April 13, 2020

Re: Site Specific Investigation
Z Homes and Properties Subdivision
(Little Valley Condos)
Addendum #1 Technical Review

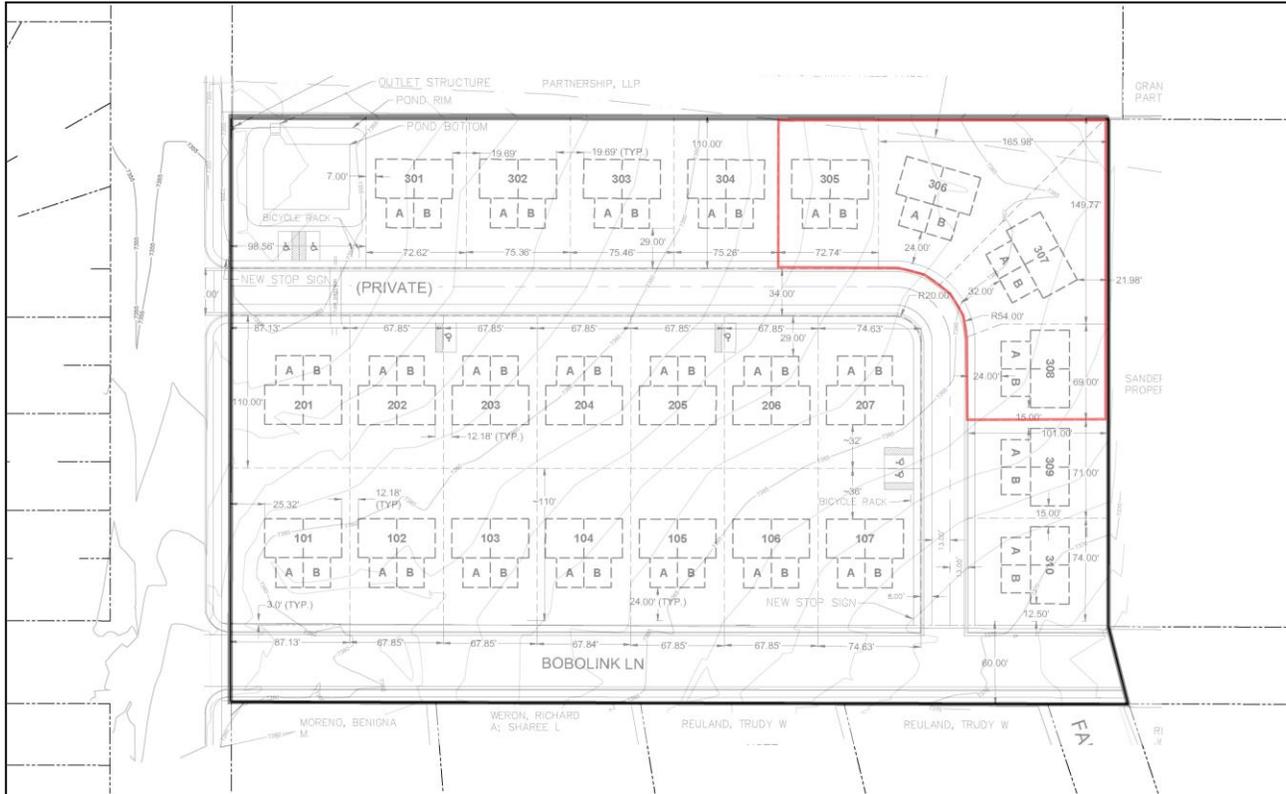
new lot layout will include approximately four (4) single-family homes. Based on the Addendum letter's reference to these homes being located in the area identified as "future development" on the preliminary plat, these single-family homes would be located on the four lots outlined in red in the figure below.

Implementing the single-family homes/lots into the subdivision will eliminate some of the stormwater runoff generated within the subdivision because single-family lots tend to have less paved and roofed surfaces and therefore, more of the precipitation is able to percolate into the soils rather than running overland. Additionally, the smaller paved area will result in less volume of leaked oil/gas on the paved surfaces to be carried off the subdivision site by the stormwater runoff.
